# Supplemental Information to the Technical Drainage Study for

## Summerlin West Grand Park Detention Basin *Las Vegas, Nevada*

*7809-GPDB*

**Subject: Supplemental Information for the Technical Drainage Study for Summerlin West Grand Park Detention Basin.**

**EXHIBIT TO ACCOMPANY LEGAL DESCRIPTION  
DETENTION BASIN DRAINAGE EASEMENT**

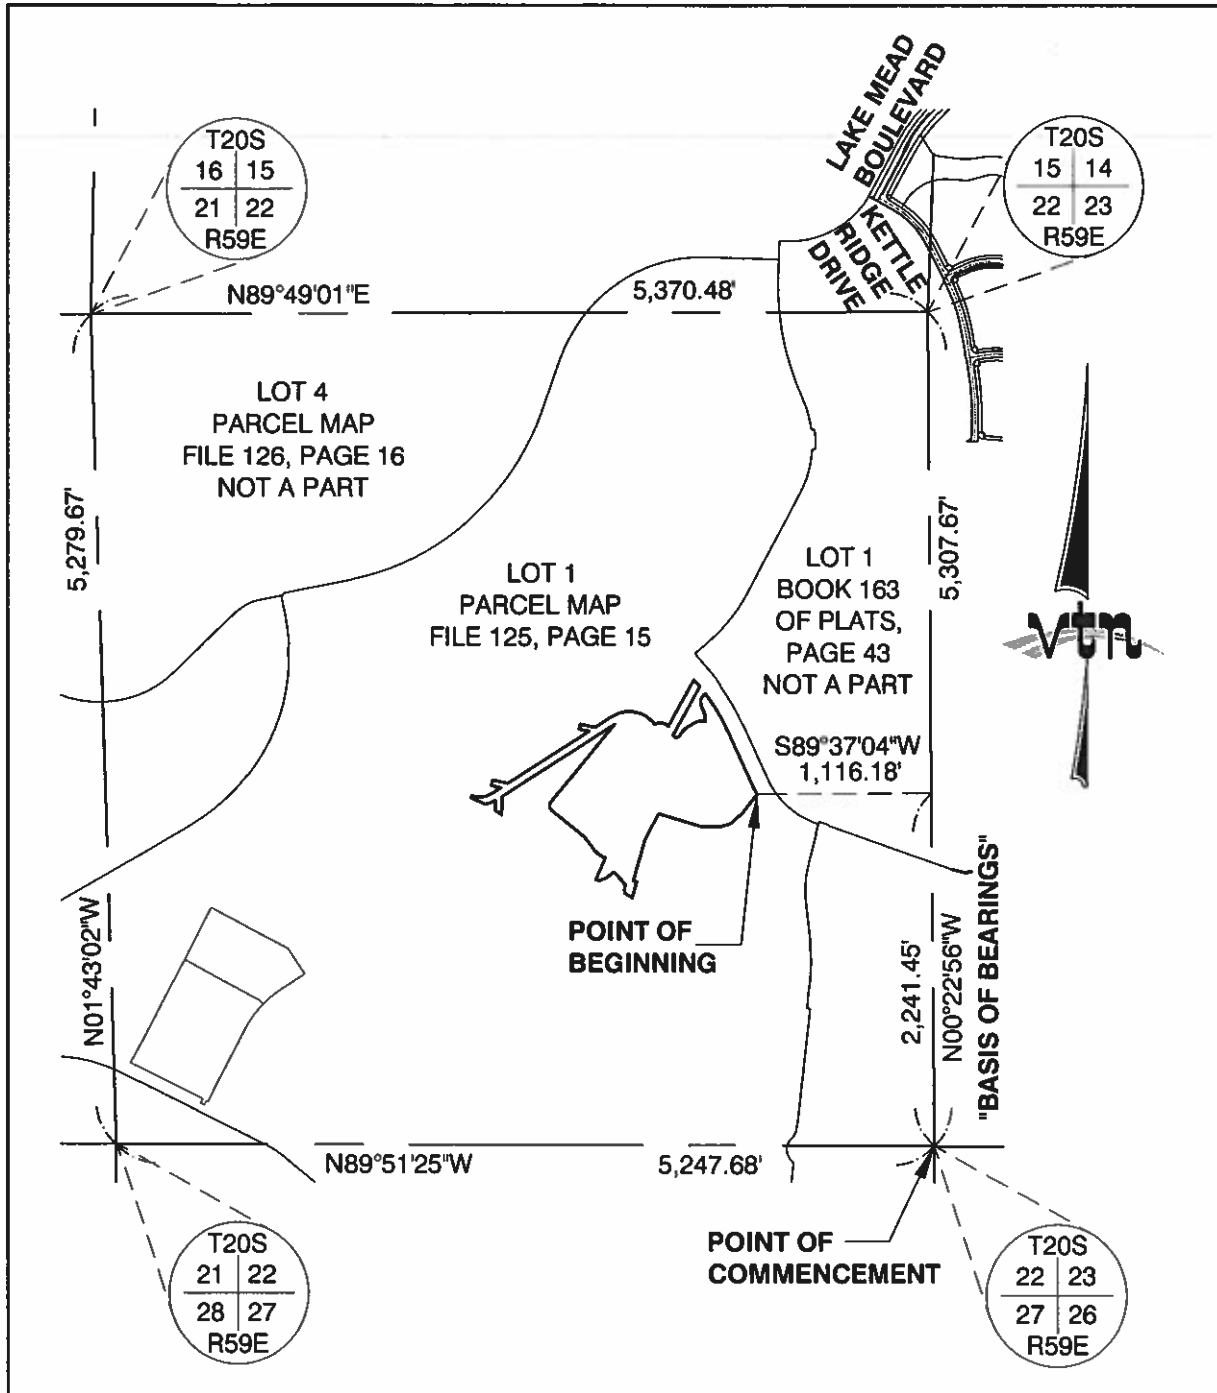
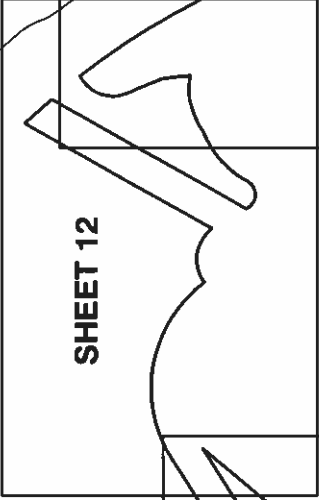
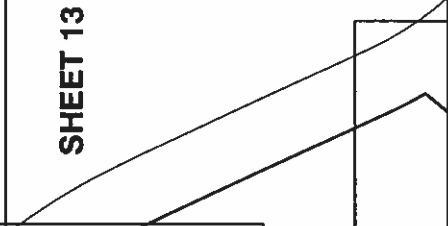
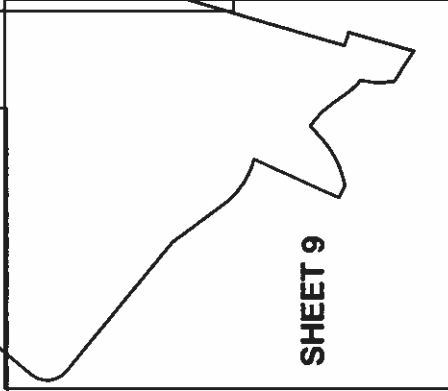
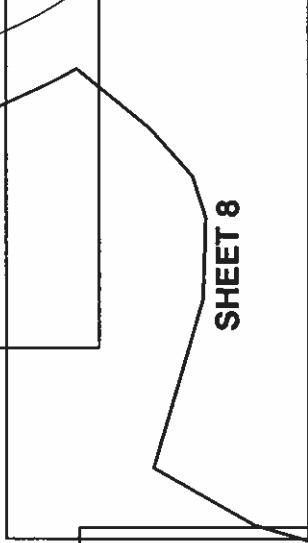
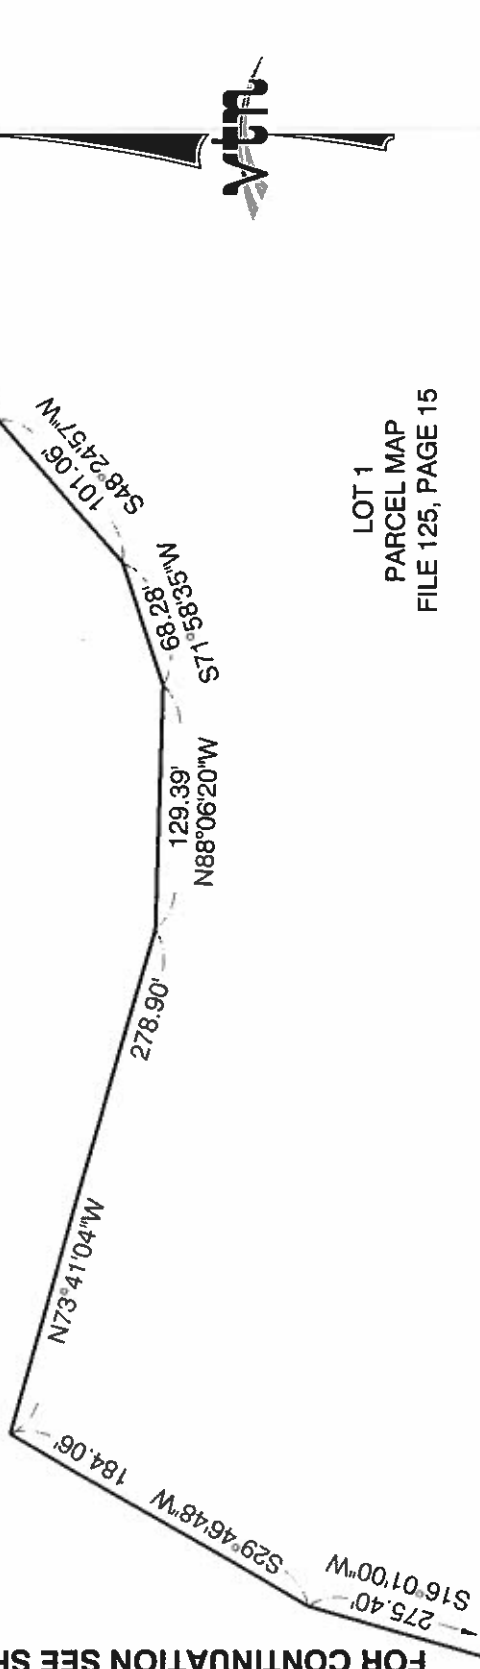
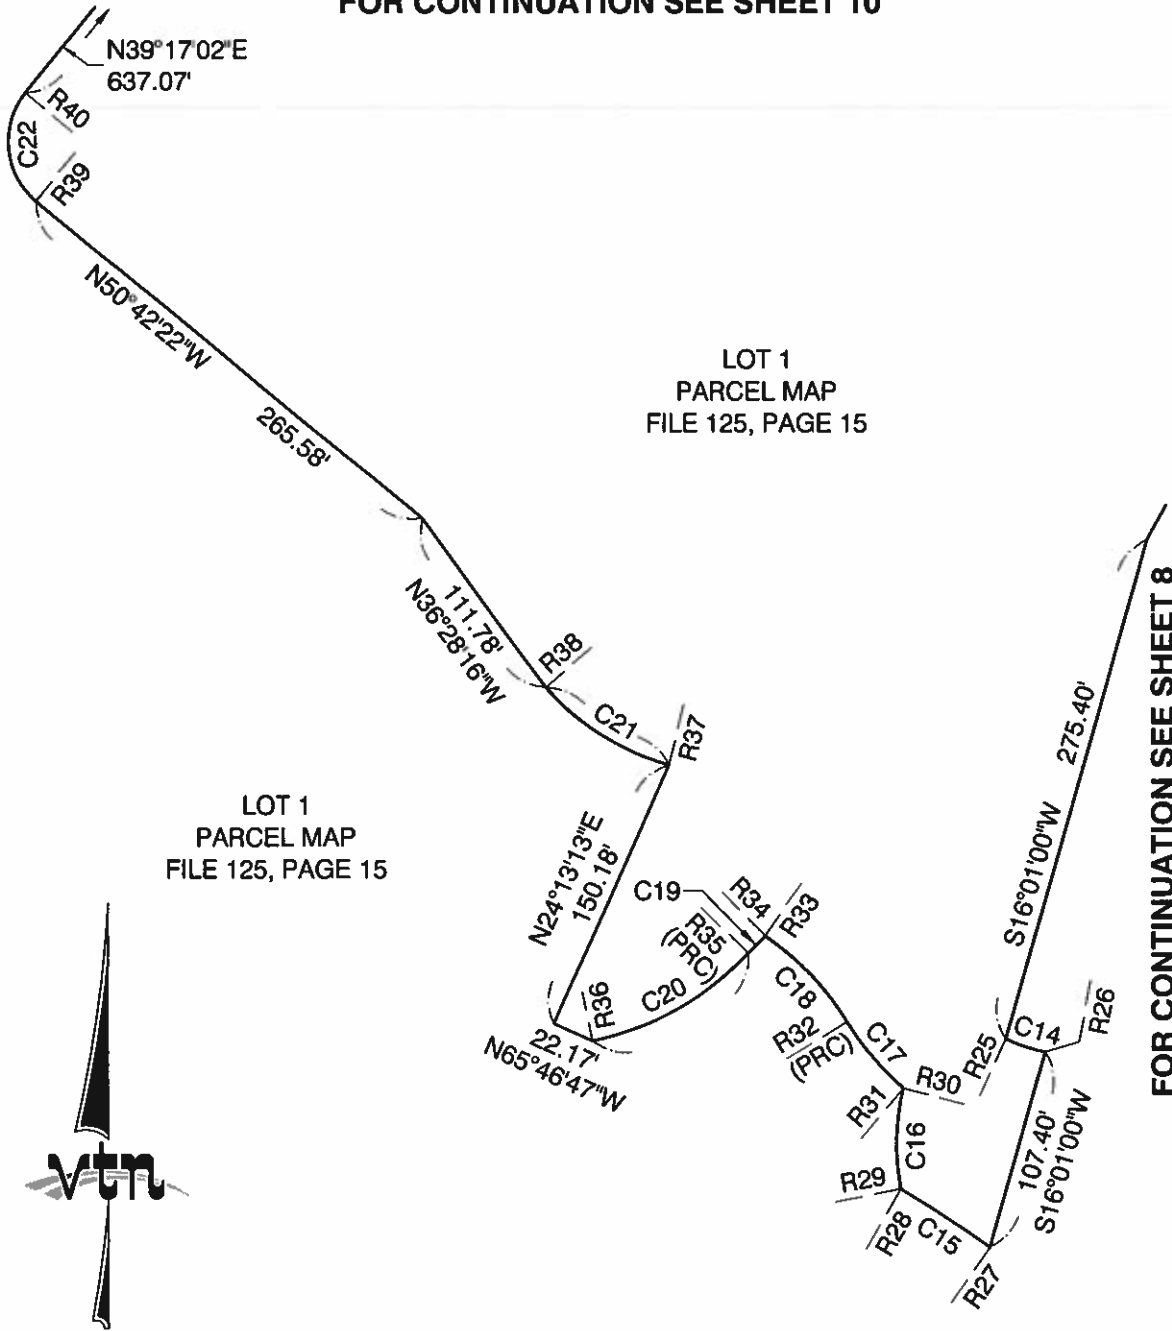
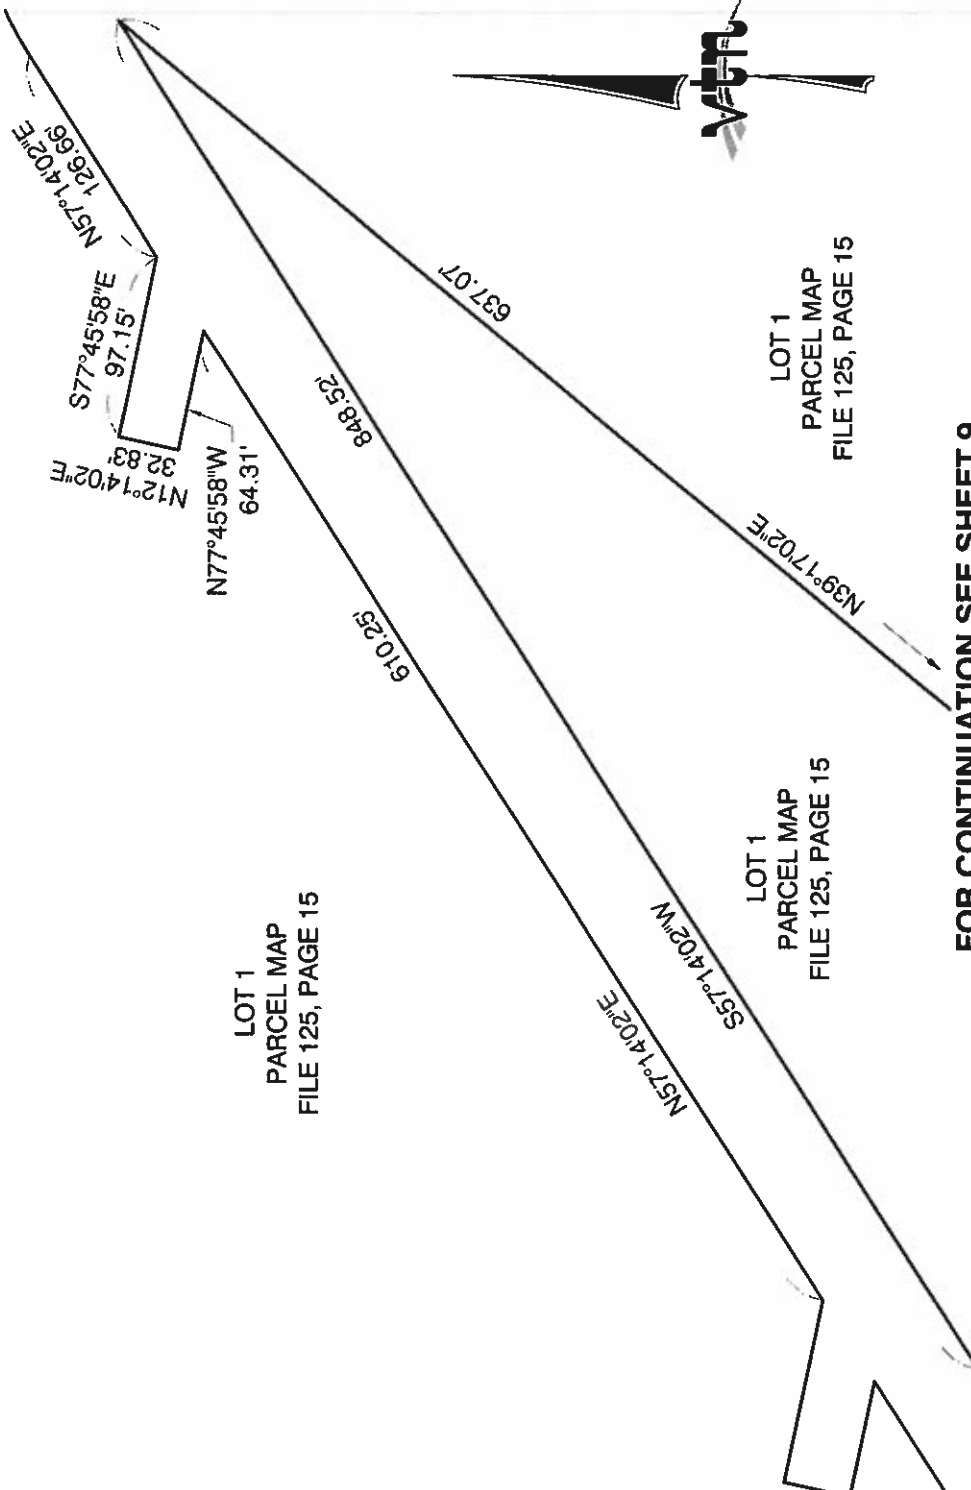
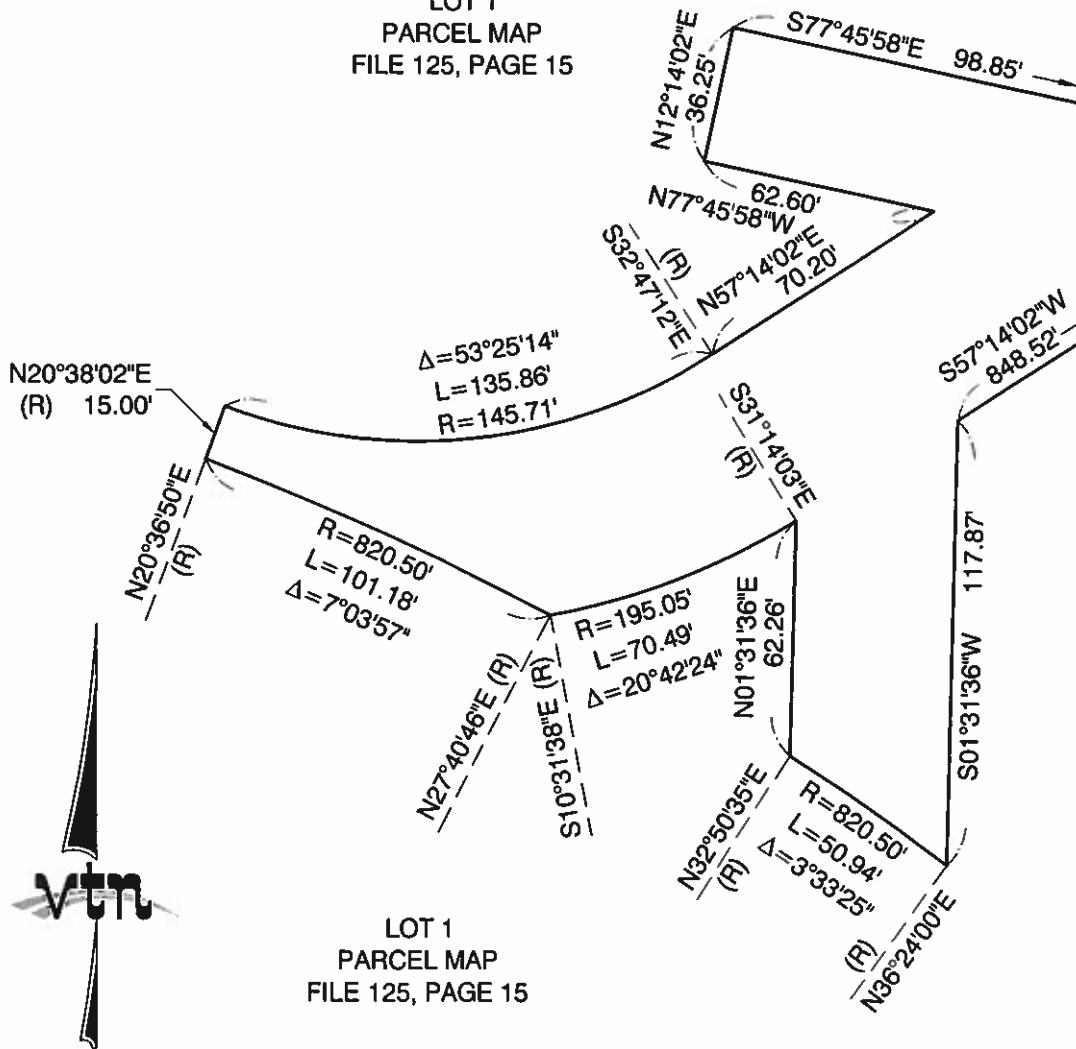
***Provide a Drainage Easement Exhibit with accompanying legal description for Flood Control approval prior to final approval of the Improvement Plans for all facilities located outside of existing right-of-way. Coordinate easement with on-going site mapping that may include the dedication of the park parcel.***

A drainage easement exhibit and legal description has been provided with this supplement.
